10/564,761

Tatsushi Ogawa

<b>Office Action Summary</b>	<b>Application No.</b> 10/564,761	<b>Applicant(s)</b> OGAWA ET AL.	
	<b>Examiner</b> LINDSAY M. LOW	<b>Art Unit</b> 3721

### **DETAILED ACTION**

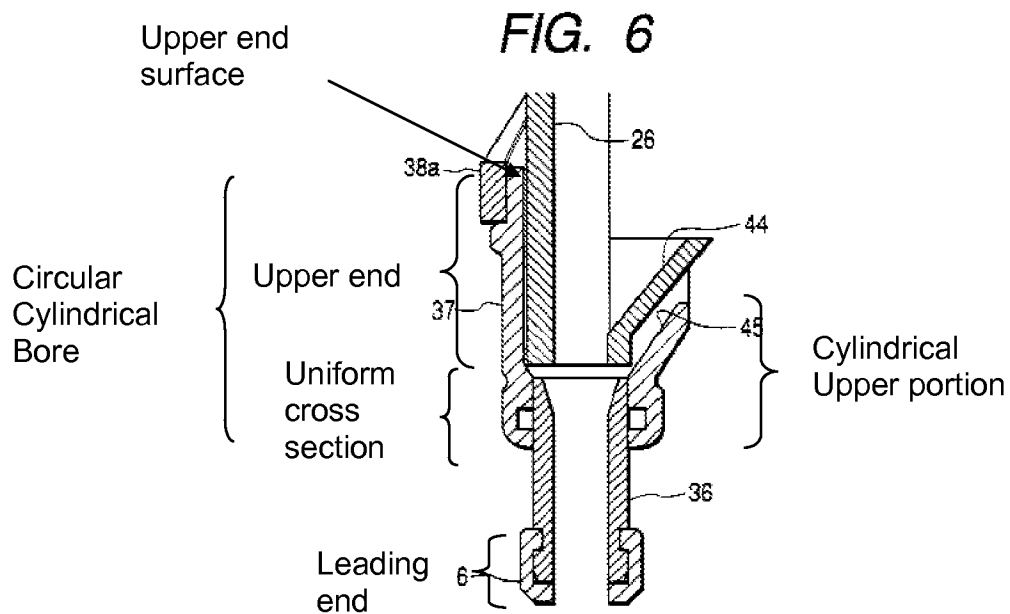
Regarding the amendments to claim 1, the designated circular cylindrical bore (reproduced below) has a longitudinal axis and a substantially uniform cross section that is transverse to the longitudinal axis. As is best understood, the circular cylindrical bore extends from an interior of the contact nose to an upper end surface that is transverse to the longitudinal axis (see designation below).

Regarding new claim 21, note that the nose body is slidable relative to the hollow member along an axis. The inner surface of the hollow member is substantially perpendicular to the axis as shown below.

Applicant contends that the prior art's nose body is not circumferentially received in the hollow member. However, referring to the figure reproduced above, the nose body is circumferentially received in the hollow member. Note that the portion of the hollow member where the nose body is received has a circumference. In other words, that portion of the hollow member surrounds the nose body.
